EXHIBIT O1 NOTICE OF VIOLATION (MANHOLES)

NOTICE OF VIOLATION

Re: Clean Water/Operations/Sewage General Sewage Manholes 1317 and 249 East Norriton Township Montgomery County

Response to Notice of Violation Letter

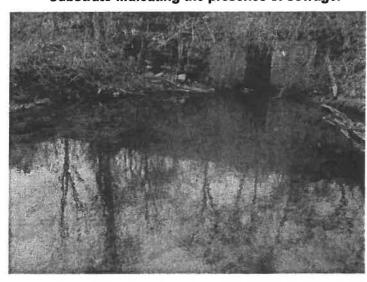
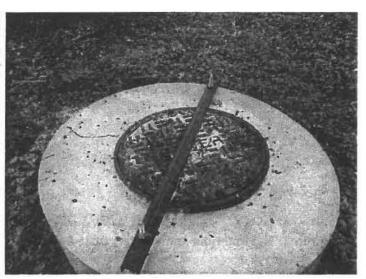
- Branch of the Stoney Creek near manholes
 1317 and 249, and with green material on the
 Substrate indicating the presence of sewage.
- 2. Manhole 1317 with solids and lime indicating an SSO Occurred, 04/18/2014

3. And 4. Manhole 1317 with sewage solids and lime on the ground around it, and erosion indicating SSOs occur at this location.

Item 1 of the NOV Letter noted erosion around the base of Manhole 1317 (actually Manhole 372). We believe this to be simply a lack of vegetation around the base of the manhole. Our inspections have found no evidence of erosion. Item 1 also detailed a "green material" in the creek. We believe that any SSO from either MH 372 or MH 371 would not have directly entered the creek due to the existing grades at this location. Both manholes are downhill from the banks of the creek, and therefore we believe that the "green material" observed in the creek did not (and could not have) resulted from any SSO from MH 372 or MH 371. Item 1 also referenced manhole 1318. We believe this was intended to refer to MH 372.

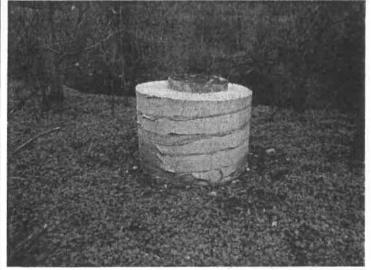
5. The Pond adjacent to the manhole 1317.

Sheen and emulsified oil on the surface of the Pond caused by an SSO on April 6, 2014.

7. and 8. The manhole immediately upstream of manhole 1317 with erosion around the base, 04/18/14.

Additionally, Item 3 on page 2 of the Inspection Report indicates that the Department observed a "petroleum based sheen" on the pond. A follow up inspection of this area was performed by Township personnel on Monday, May 5th, and while some type of substance was noted on the surface of the pond, no evidence of any sanitary sewer fats, oils or grease were observed on the surface of the pond or in the immediate vicinity of either MH 372 or MH 371.

Item 4 on page 2 of the Inspection Report also raises concerns with MH 373 and MH 374 immediately upstream of the area in question. The Township personnel recently encased both of these manholes in concrete to prevent deterioration of these structures. We believe the "erosion" noted in the report is simply a lack of vegetation due to the recent encasement process. We also investigated the possibility of SSOs at these manholes and found no physical evidence that an SSO occurred at either location.

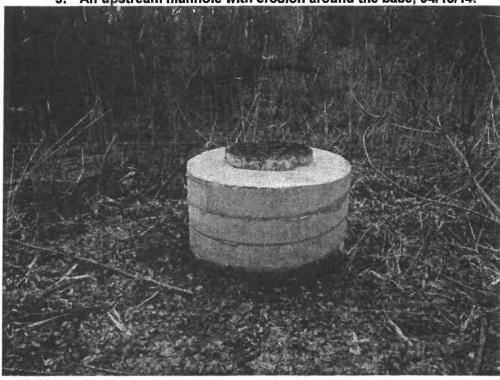
9. An upstream manhole with erosion around the base, 04/18/14.

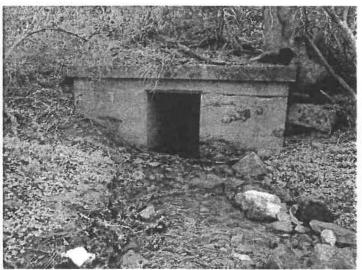
10. And 11. The section of Stoney Creek upstream of manhole 1317 and with no dark green material on the substrate or in the water column, 04/18/14.
